Subject: Evaluation of Potential Hydrologic Effects
THP No. 1-04-059 SON and Proposed Mitigated Negative Declaration TCP No.04-531
Sleepy Hollow (Martin) THP/Conversion, Annapolis, California

The purpose of this letter is to present my comments and opinions regarding likely project induced environmental impacts in the Little Creek and Grasshopper Creek watersheds associated with the Sleepy Hollow (Martin) Timber Harvest Plan and (Vineyard) Conversion (THP Number 1-04-059 SON and TCP No. 04-531). My conclusions are based on reviewing the following project planning documents:

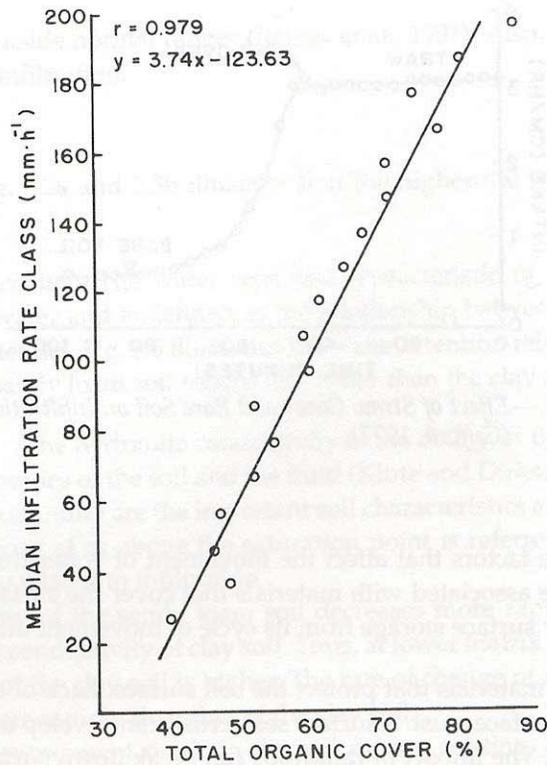
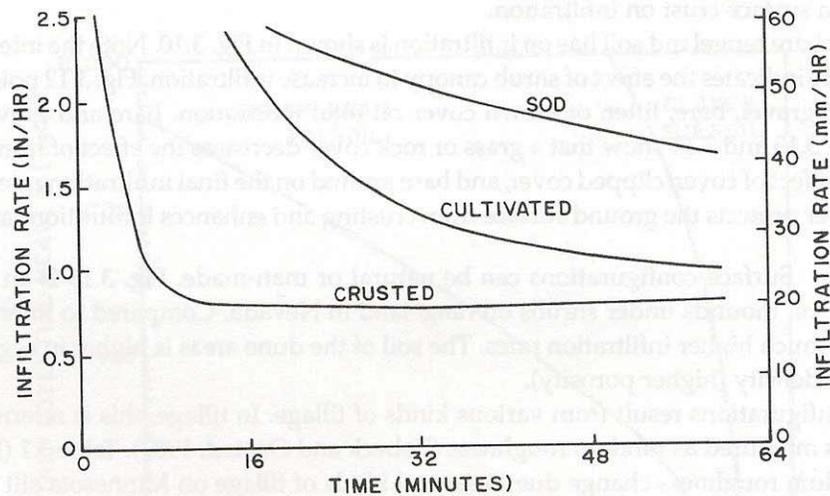
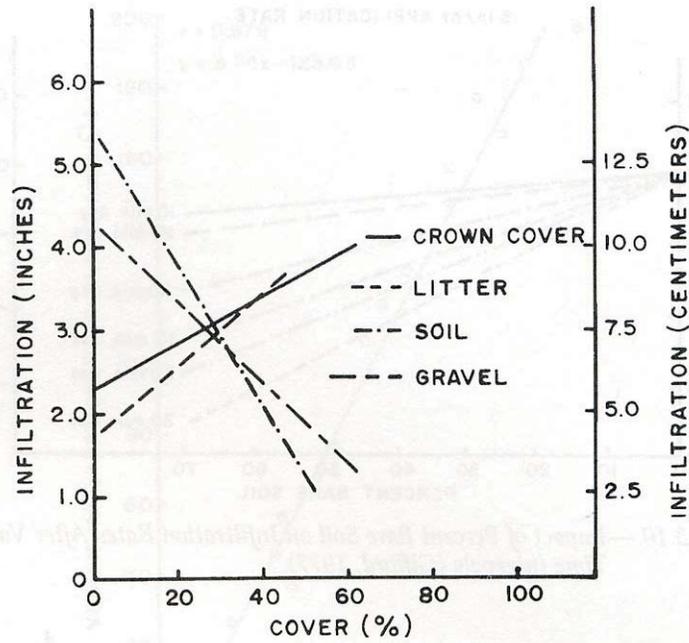
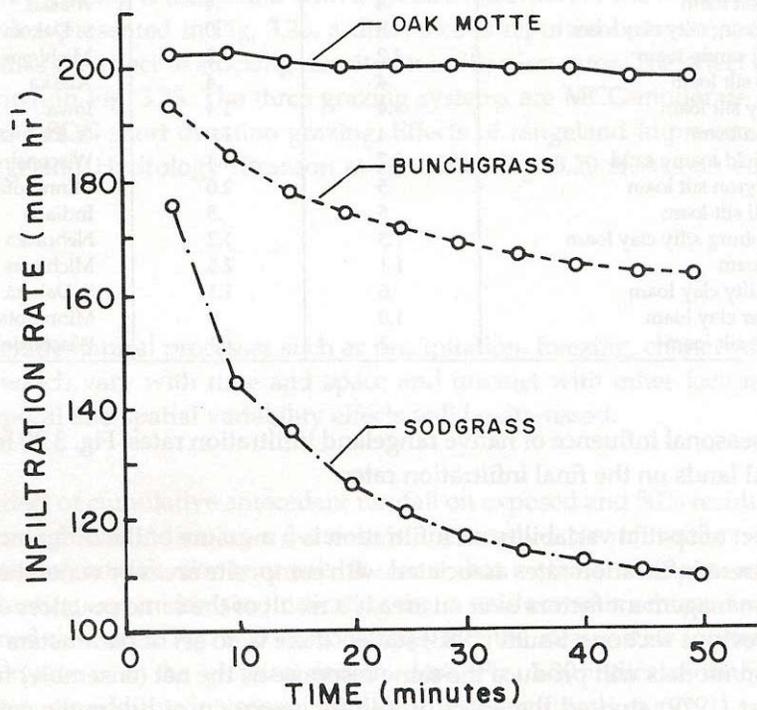
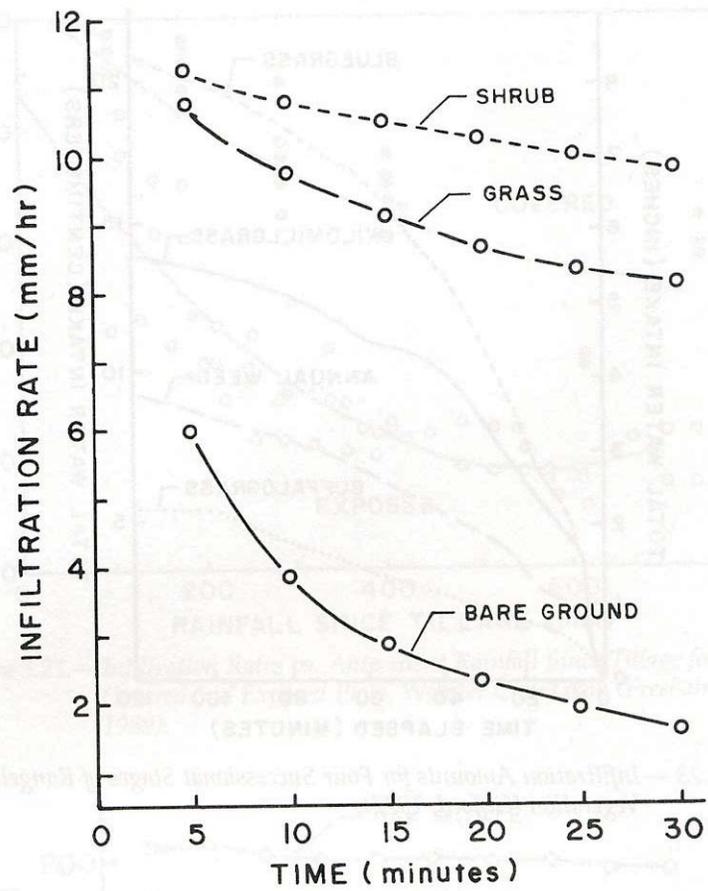
infiltration and “contributing to low-flow based flows in the lower reaches of Little Creek” (2003 Erickson report, page 4), only 37-percent will be available for infiltration. Another problem is that these figures only reflect existing watershed conditions. In order to properly quantify the impacts of the project on hydrologic conditions, one needs to develop a detailed water budget comparing the perceived gains in available soil moisture as a result of logging against the retained vegetation water demands (evapotranspiration) and infiltration potential from the altered substrate. The relationships between groundcover type and infiltration potential are well understood as exemplified in the attached Figures. In general, these figures² demonstrate:

- Increased organic cover leads to increased infiltration rates;
- Areas covered in vegetation have higher infiltration rates than cultivated areas; and
- Forested areas commonly have higher infiltration rates than grasslands.

The last of these bullets is in direct opposition to the claim in the 2003 Erickson report that states the vineyard will have an infiltration rate similar to forested conditions.
